Agenda
Village of Glen Ellyn
Capital Improvements Commission Meeting
Tuesday, June 13, 2023
7:00 PM
Glen Ellyn Civic Center, Room 301

Civil Plan – Note, these include progress review comments merely for context

TS&L Plans – Note, these include in progress review comments merely for context

GENERAL PLAN AND ELEVATION
PEDESTRIAN TUNNEL
GLEN ELLYN METRA STATION
SECTION 18-00082-00-MS
DUPAGE COUNTY
STATION 3604+41.45

CONCEPTUAL SITE PLAN

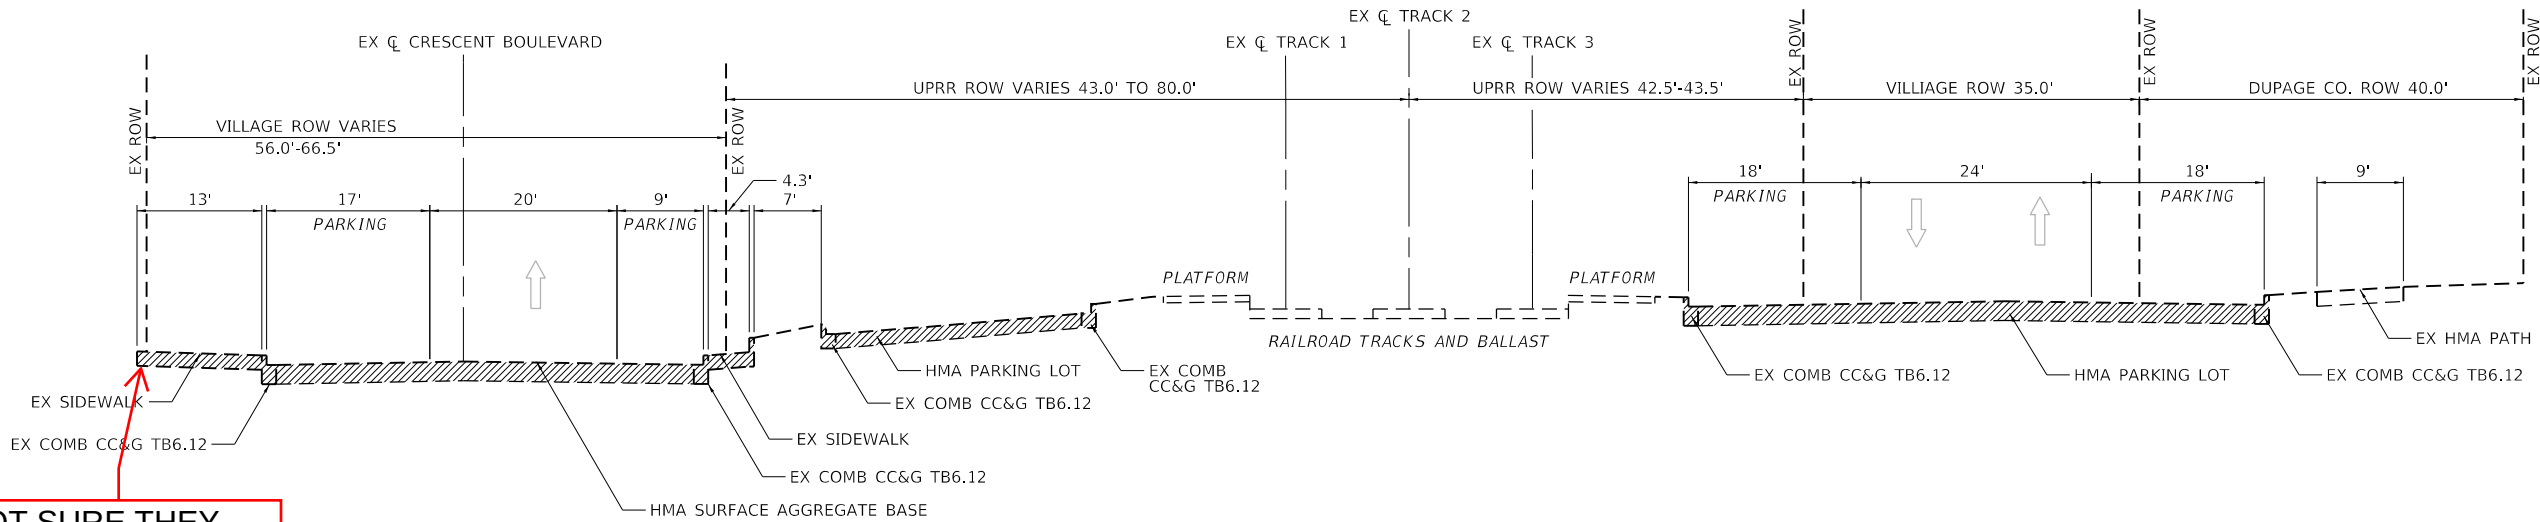
NOT SURE THEY
WILL FLAG IT AT
THIS POINT...THEY
SHOULD BUT WE
DO HAVE
EASEMENTS FOR
THE AREA OF
SIDEWALK
BETWEEN THE
ROW AND
BUILDINGS. I WILL
TRANSMIT THEM TO
STEVE H. AND BOB
C.

NOT CRITICAL BUT
WERE SECTIONS
NOT DRAWN WITH
ASSEMBLIES?
THEY ARE NOT TO
SCALE.

EXISTING TYPICAL SECTION

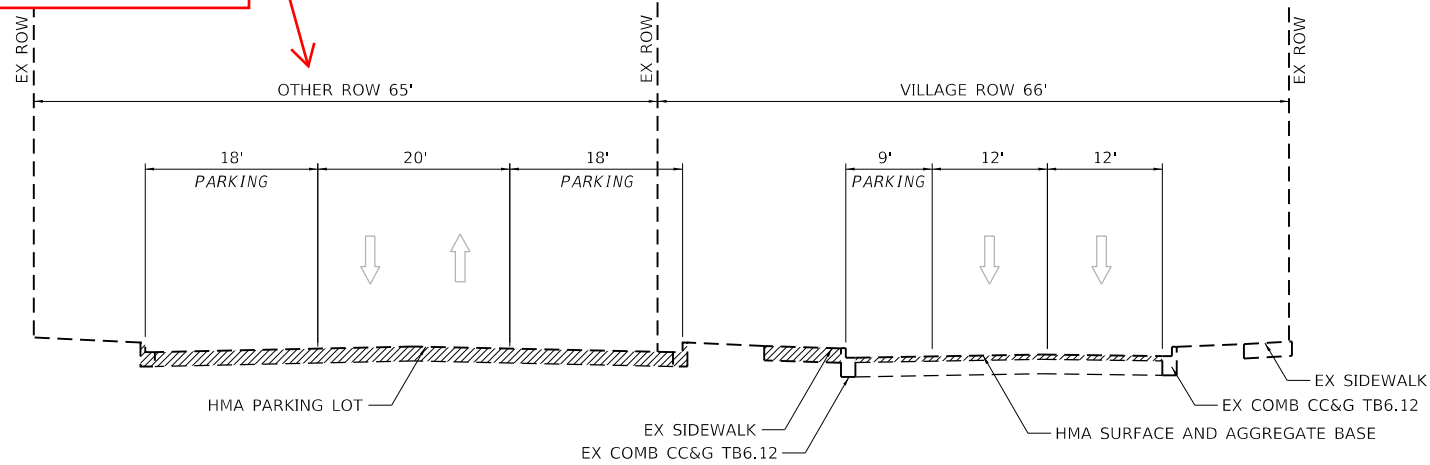
SHOULD THIS BE LISTED AS VILLAGE PROPERTY?

PROPOSED TYPICAL SECTION

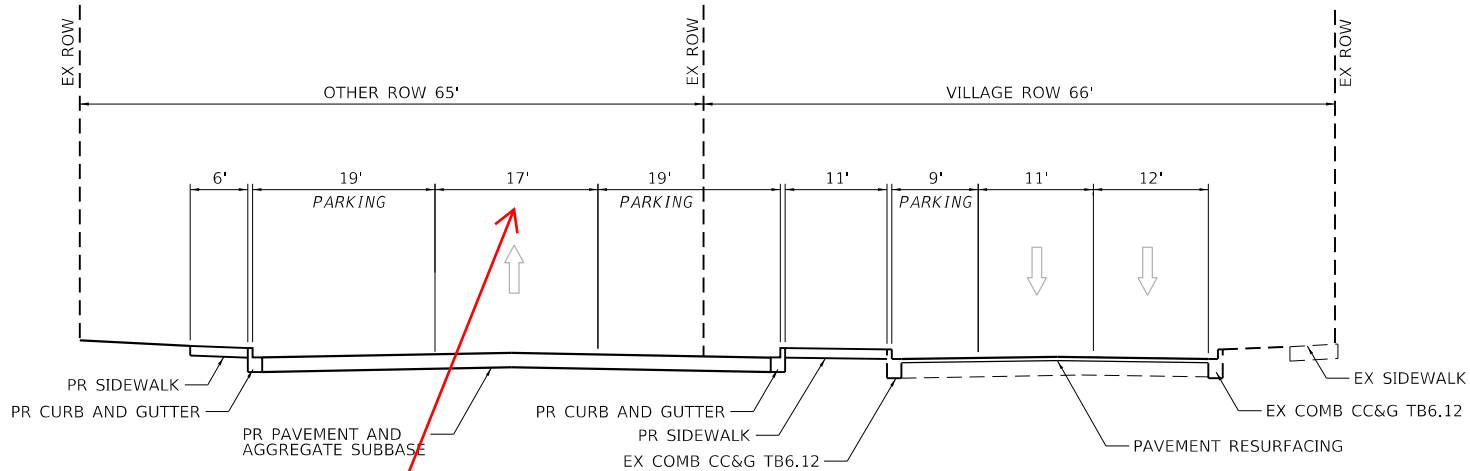
DIMENSIONS DON'T
MATCH PLAN VIEW

ROADWAY PLAN

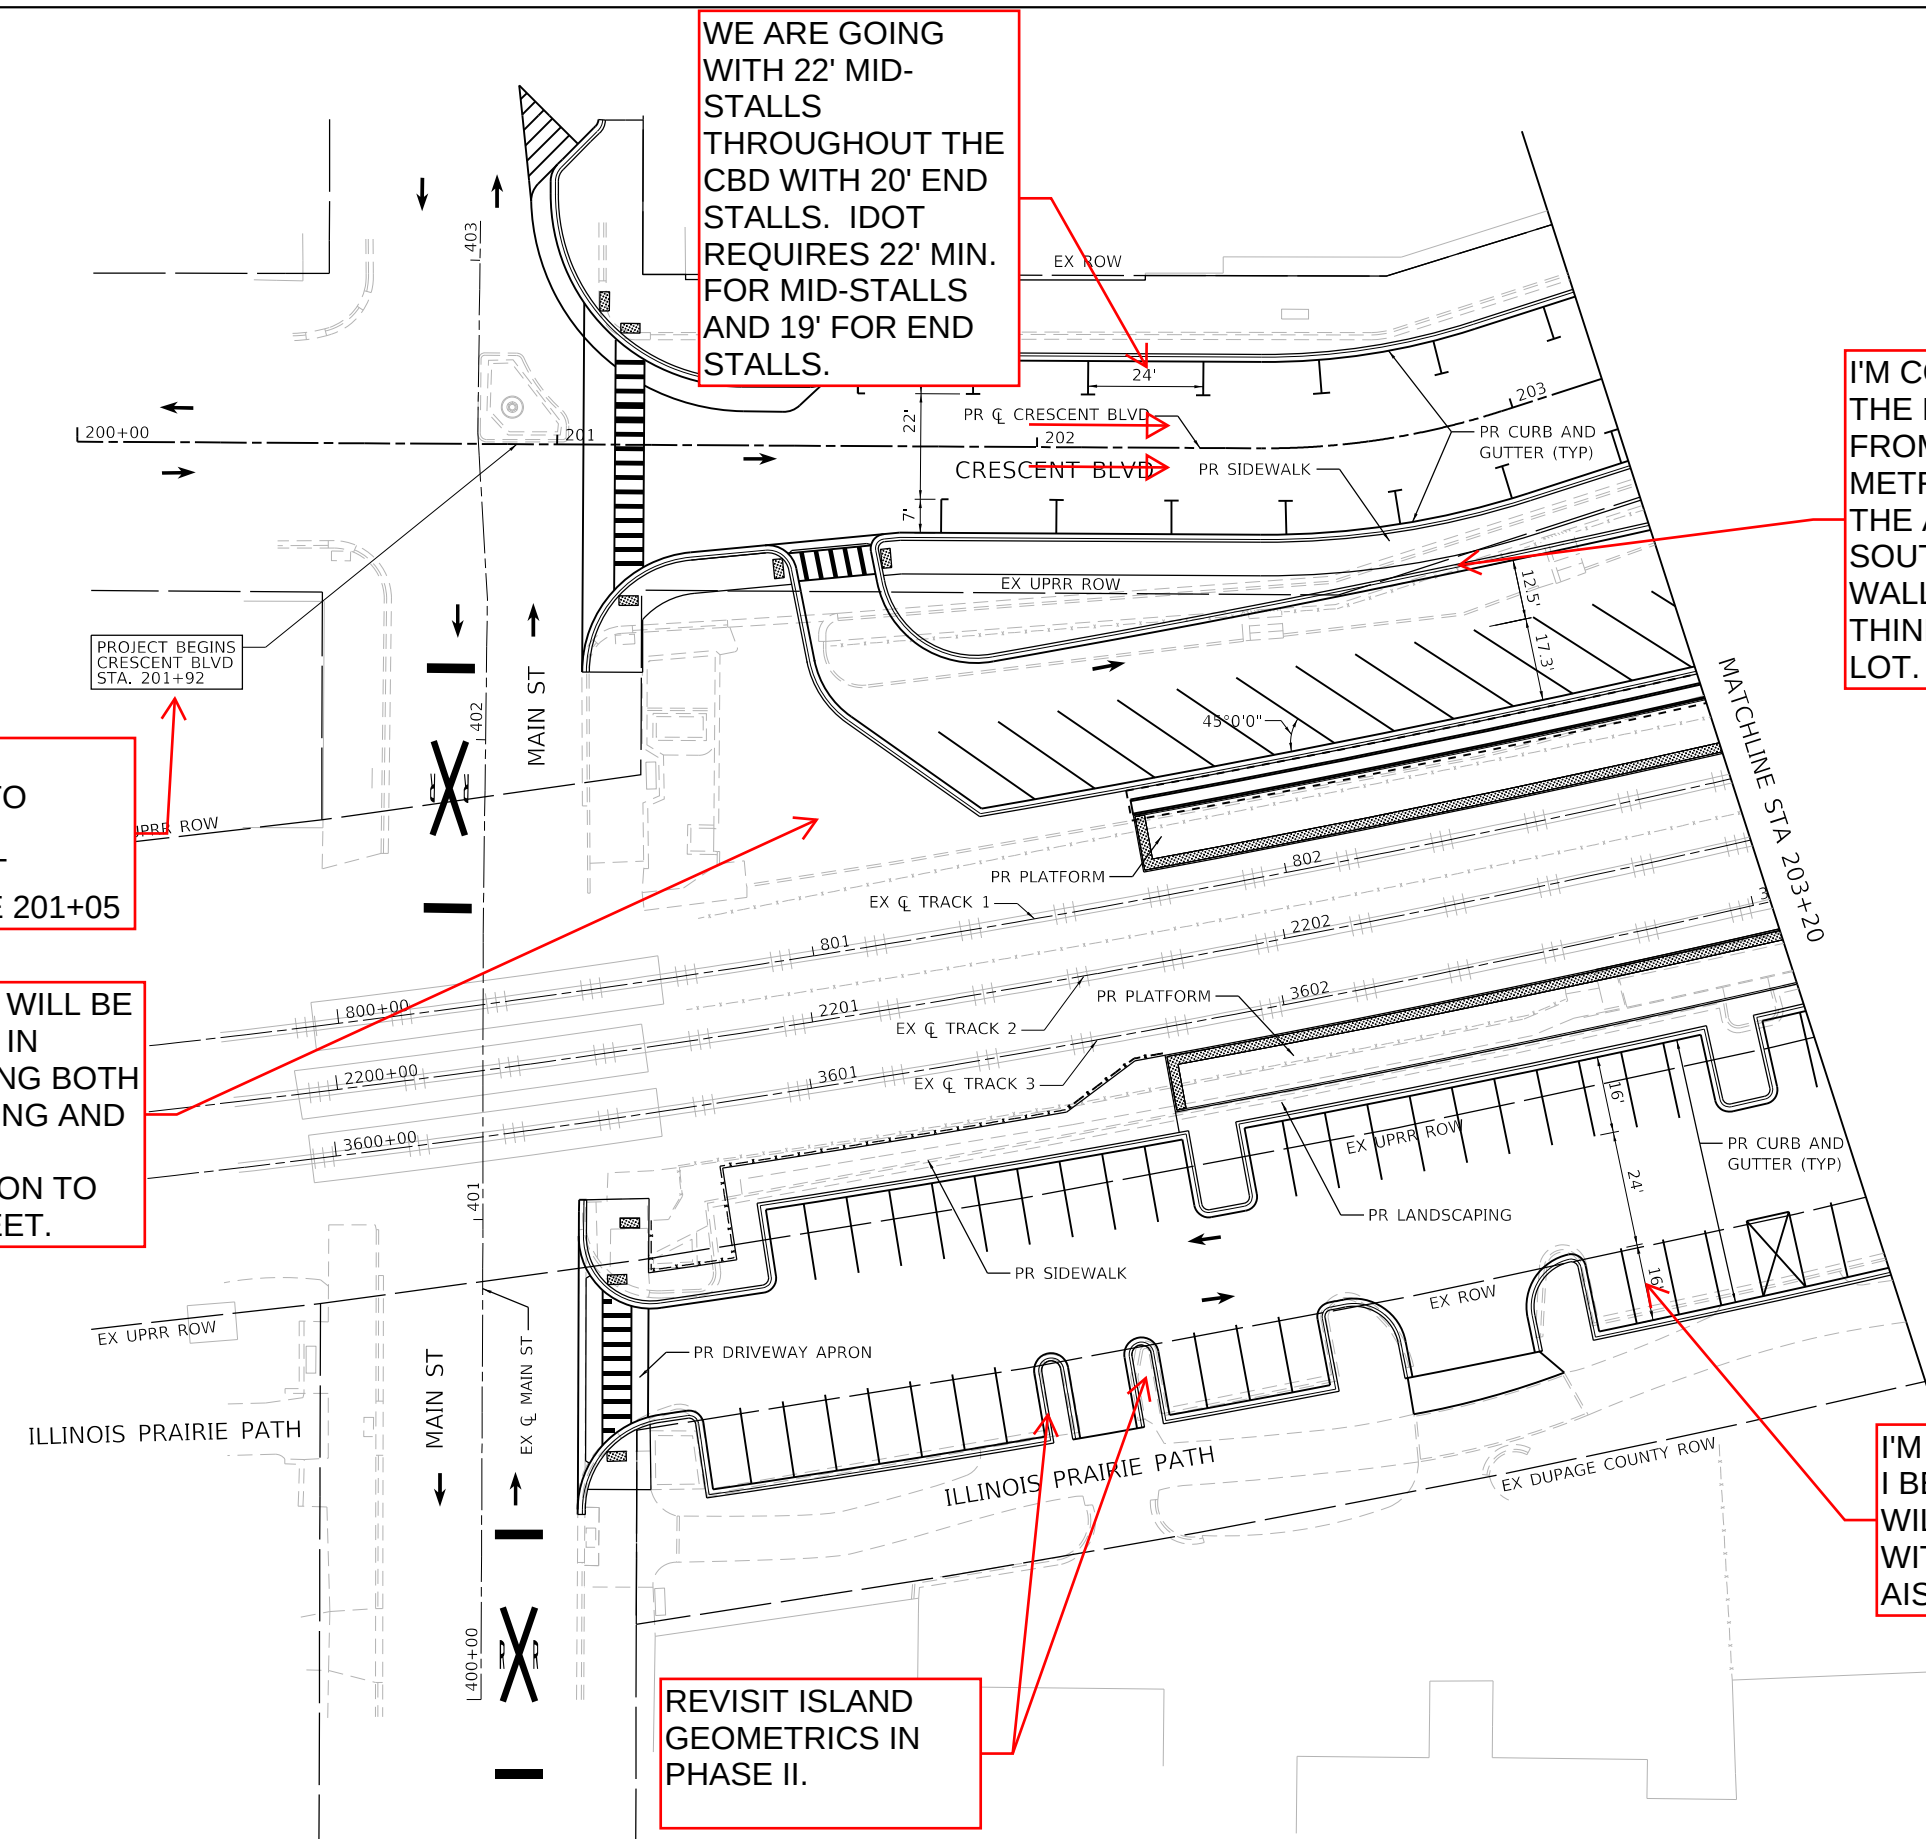
WE ARE GOING WITH 22' MID-STALLS THROUGHOUT THE CBD WITH 20' END STALLS. IDOT REQUIRES 22' MIN. FOR MID-STALLS AND 19' FOR END STALLS.

I'M CONCERNED ABOUT THE GEOMETRICS HERE WITH THE POTENTIAL CONFLICT FOR BACKING VEHICLES FROM THE SURFACE LOT. JUST LOOKING AT ITE AND METRA STANDARDS, WE CAN REDUCE THE DEPTH OF THE ANGLE SPACES TO 16.5' AND PUSH THE CURB SOUTH. WE COULD ALSO CONSIDER A GUARDRAIL, WALL, OR CRASH RATED FENCE BUT WE NEED TO THINK ABOUT HOW PEOPLE WILL SAFELY WALK IN THE LOT. FUN DETAILS TO DIVE INTO DURING PHASE II!

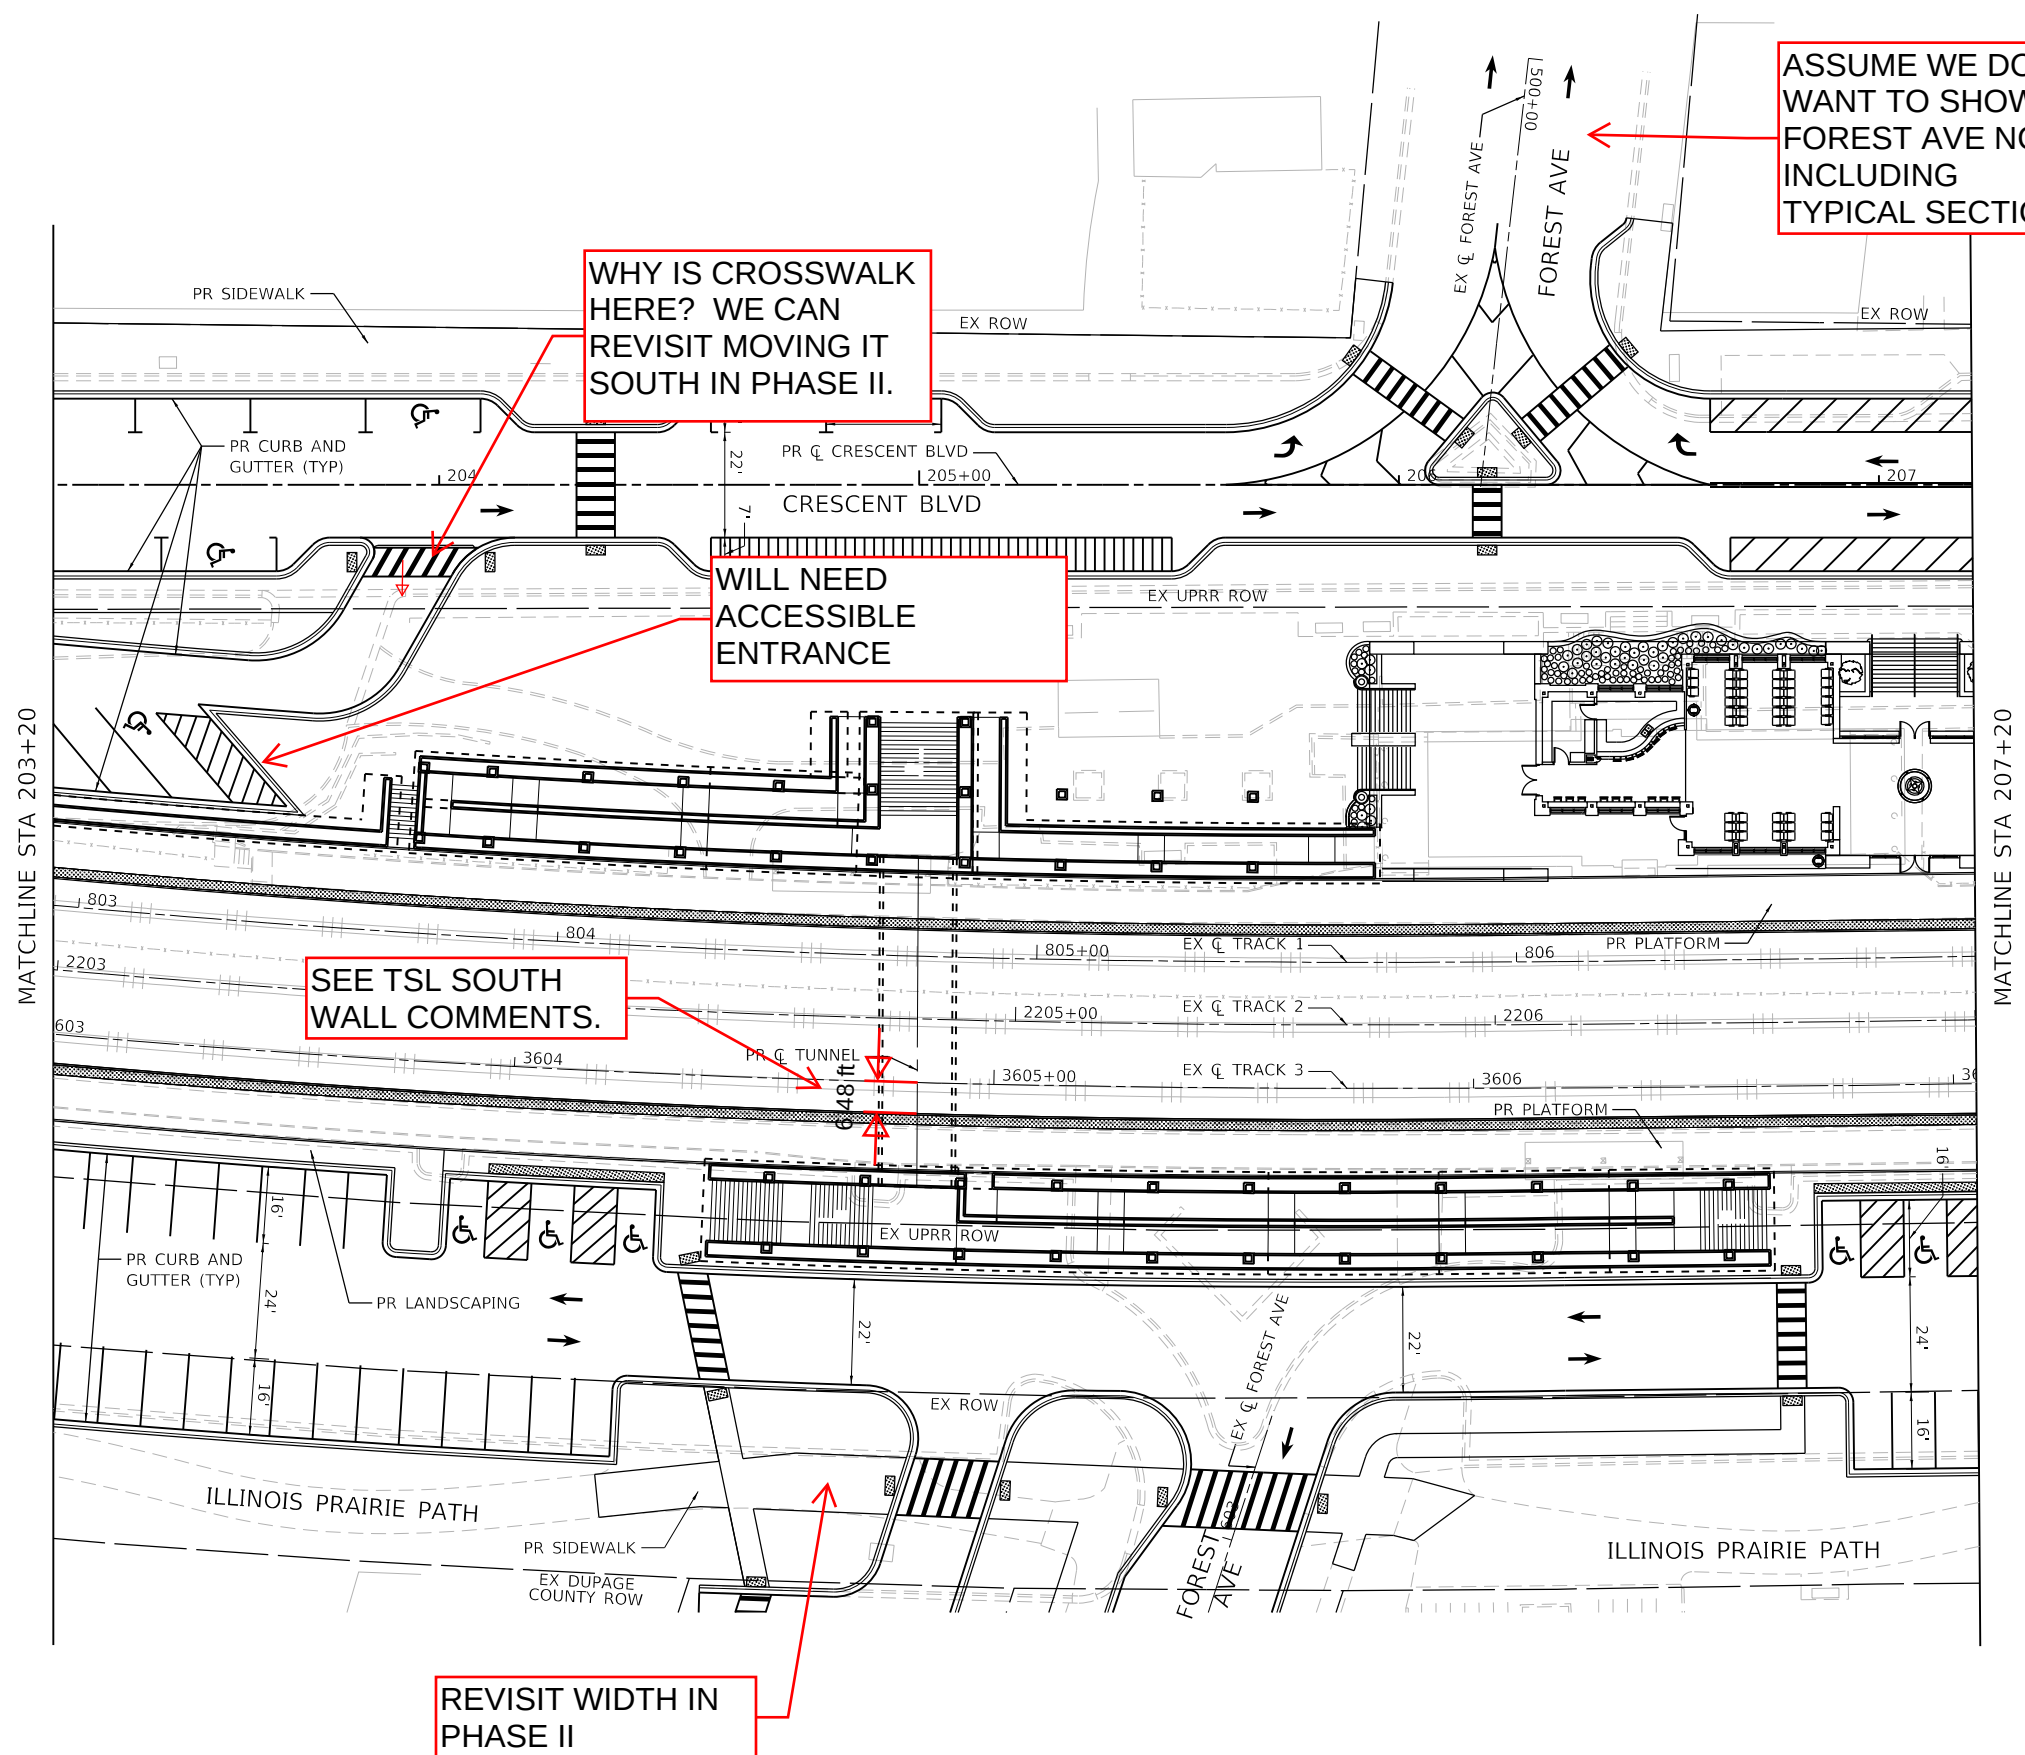
WILL NEED
ACCESSIBLE ROUTE
TO

REPEAT CONCERN/DESIRE
TO REVISIT PARKING
GEOMETRICS IN PHASE II.
